#### 186th session

## **Proposal for Supplement 14 to the 02 series of amendments to UN Regulation No. 117 (Tyre rolling resistance, rolling noise and wet grip)**

### **Submitted by the Working Party on Noise and Tyres\***

### Examples of separate UN Regulation No. 117 approval marks

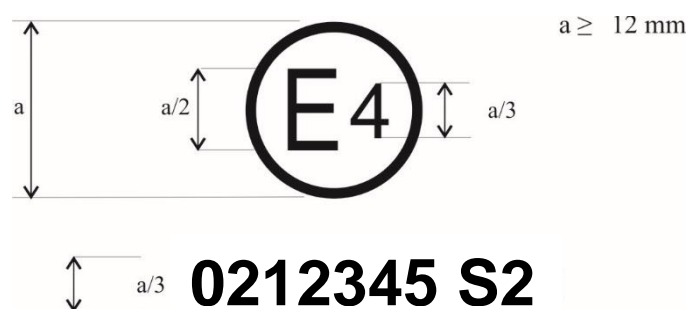
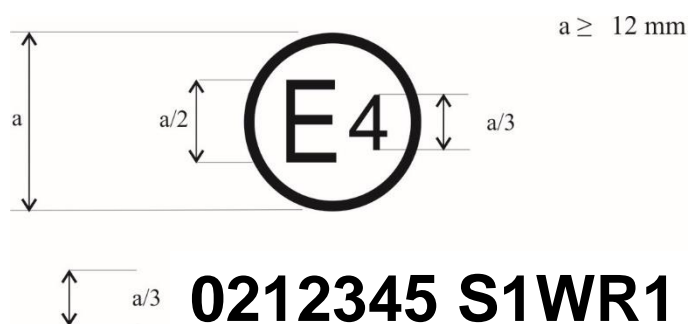
Annex 2 - Appendix 1, amend to read:

The above approval mark, affixed to a tyre shows that a tyre concerned has been approved in the Netherlands (E 4) pursuant to Regulation No. 117 (marked by "S2"), under approval number 0212345. This indicates that the approval is for rolling sound at stage 2 (S2). The first two digits of the approval number (02) indicate that the approval was granted in accordance with this Regulation which included 02 series of amendments.

The above approval mark shows that the tyre concerned has been approved in the Netherlands (E 4) pursuant to Regulation No. 117 (marked by "S1WR1") under approval number 0212345. This indicates that the approval is for rolling sound at stage 1 (S1), wet adhesion (W) and rolling resistance at stage 1 (R1). The first two digits of the approval number ("02") indicate that the approval was granted in accordance with this Regulation which included the 02 series of amendments."

**Approval according to UN Regulation No. 117 coincident with approval of UN Regulations Nos. 30 or 54**

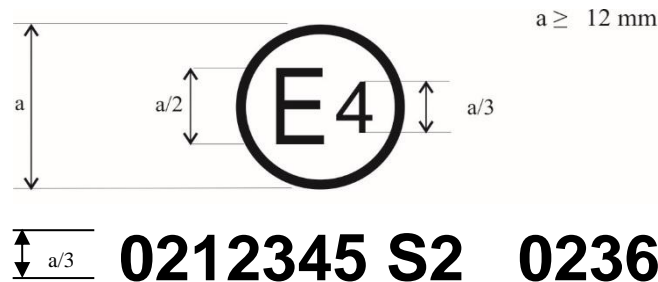
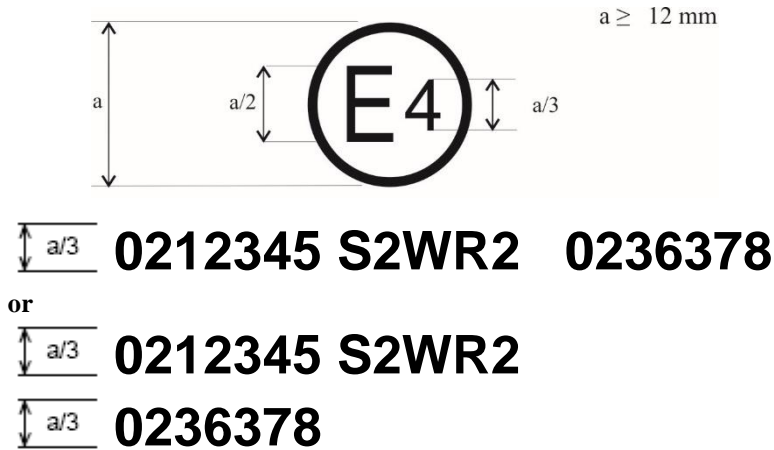
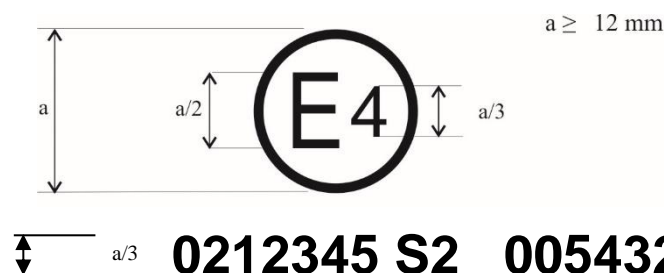
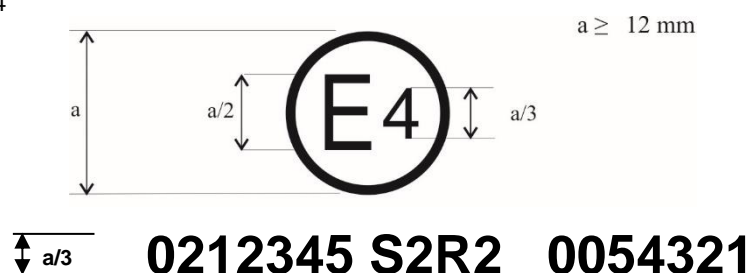
Annex 2 - Appendix 2, delete footnote 1 and amend to read:

The above approval mark shows that the tyre concerned has been approved in the Netherlands (E 4) pursuant to UN Regulation No. 117 (marked by "S2"), under approval number 0212345 and UN Regulation No. 30, under approval number 0236378. This indicates that the approval is for rolling sound at stage 2 (S2). The first two digits of the approval number ("02") in conjunction with "S2" indicate that the approval was granted in accordance with UN Regulation No. 117 which included the 02 series of amendments. The first two digits of the UN Regulation No. 30 approval number ("02") indicate that this Regulation included the 02 series of amendments.

The above approval mark shows that the tyre concerned has been approved in the Netherlands (E 4) pursuant to UN Regulation No. 117 (marked by "S2WR2"), under approval number 0212345 and UN Regulation No. 30, under approval number 0236378. This indicates that the approval is for rolling sound at stage 2 (S2), wet adhesion (W) and rolling resistance at stage 2 (R2). The first two digits of the approval number ("02") in conjunction with "S2WR2" indicate that the first approval was granted in accordance with UN Regulation No. 117 which included the 02 series of amendments. The first two digits of the UN Regulation No. 30 approval number ("02") indicate that this Regulation included the 02 series of amendments.

The above approval mark shows that the tyre concerned has been approved in the Netherlands (E 4) pursuant to UN Regulation No. 117 and the 02 series of amendments under approval number 0212345 (marked by "S2"), and UN Regulation No. 54, under approval number 0054321. This indicates that the approval is for rolling sound stage 2 (S2). The first two digits of the UN Regulation No. 117 approval number ("02") in conjunction with "S2" indicate that the first approval was granted in accordance with UN Regulation No. 117 which included the 02 series of amendments. The first two digits of the UN Regulation No. 54 approval number ("00") indicate that this Regulation was in its original form.

The above approval mark shows that the tyre concerned has been approved in the Netherlands (E 4) pursuant to UN Regulation No. 117 and the 02 series of amendments under approval number 0212345 (marked by "S2R2"), and UN Regulation No. 54, under approval number 0054321. This indicates that the approval is for rolling sound stage 2 (S2) and rolling resistance stage 2 (R2). The first two digits of the UN Regulation No. 117 approval number ("02") in conjunction with "S2R2" indicate that the first approval was granted in accordance with UN Regulation No. 117 which included the 02 series of amendments. The first two digits of the UN Regulation No. 54 approval number ("00") indicate that this Regulation was in its original form."

### Combinations of markings of approvals issued in accordance with UN Regulations Nos. 117, 30 or 54

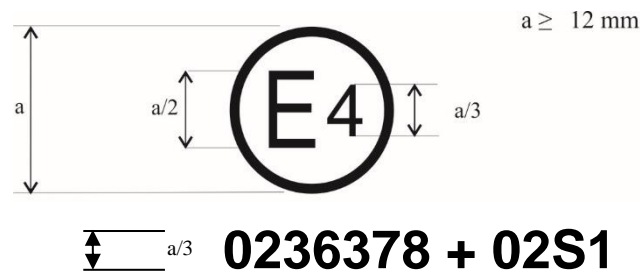
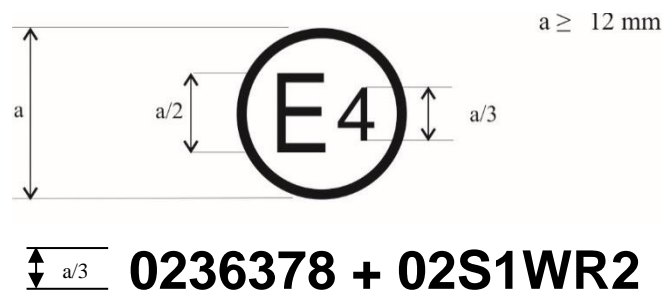
Annex 2 - Appendix 3, amend to read:

The above approval mark shows that the tyre concerned has been approved in the Netherlands (E 4) pursuant to UN Regulation No. 30 according to its 02 series of amendments (indicated by the first two digits of the approval number, "02") under approval number 0236378. It is also marked by "+ 02S1" which indicates that the tyre was also approved pursuant to UN Regulation No. 117 (02 series of amendments) for rolling sound at stage 1.

The above approval mark shows that the tyre concerned has been approved in the Netherlands (E 4) pursuant to Regulation No. 30 according to its 02 series of amendments (indicated by the first two digits of the approval number, "02") under approval number 0236378. It is also marked by "+ 02S1WR2" which indicates that the tyre was also approved pursuant to UN Regulation No. 117 (02 series of amendments) for S1 (rolling sound at stage 1), W (wet adhesion) and R2 (rolling resistance at stage 2)."

### Extensions to combine approvals issued in accordance with Regulation No. 117

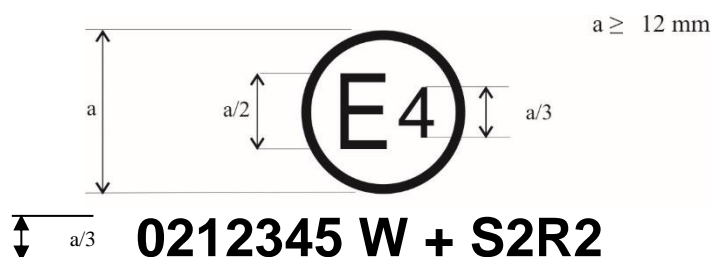
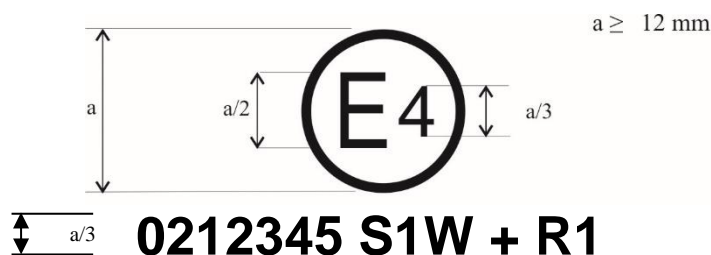
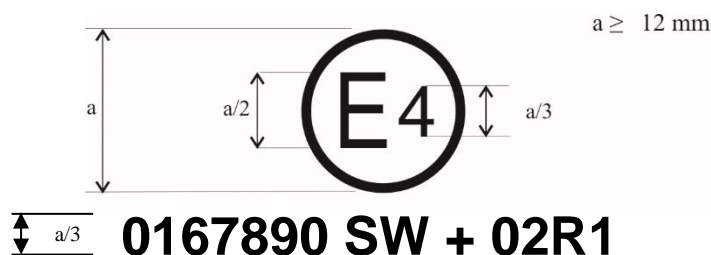
Annex 2 - Appendix 4, delete footnote 1 amend to read:

The above approval mark shows that the tyre concerned has been initially approved in the Netherlands (E 4) pursuant to UN Regulation No. 117 according to its 02 series of amendments (indicated by the first two digits of the approval number, "02") under approval number 0212345 (marked by "W"). This indicates that the approval is for W (wet adhesion). The "S2R2" preceded by "+" indicates that its approval has been extended under UN Regulation No. 117 to rolling sound at stage 2 and rolling resistance at stage 2 based on separate certificate(s).

The above approval mark shows that the tyre concerned has been initially approved in the Netherlands (E 4) pursuant to UN Regulation No. 117 according to its 02 series of amendments (indicated by the first two digits of the approval number, "02") under approval number 0212345 (marked by "S1W"). This indicates that the approval is for S1 (rolling sound at stage 1) and W (wet adhesion). The "R1" preceded by "+" indicates that its approval has been extended under Regulation No. 117 to rolling resistance at stage 1 based on separate certificate(s).

The above approval mark shows that the tyre concerned has been initially approved in the Netherlands (E 4) pursuant to UN Regulation No. 117 according to its 01 series of amendments (indicated by the first two digits of the approval number, "01") under approval

number 0167890 (marked by "SW"). This indicates that the approval is for S (rolling sound at stage 1) and W (wet adhesion). The "02R1" preceded by "+" indicates that its approval has been extended under UN Regulation No. 117 according to its 02 series of amendments to rolling resistance at stage 1 based on separate certificate(s)."
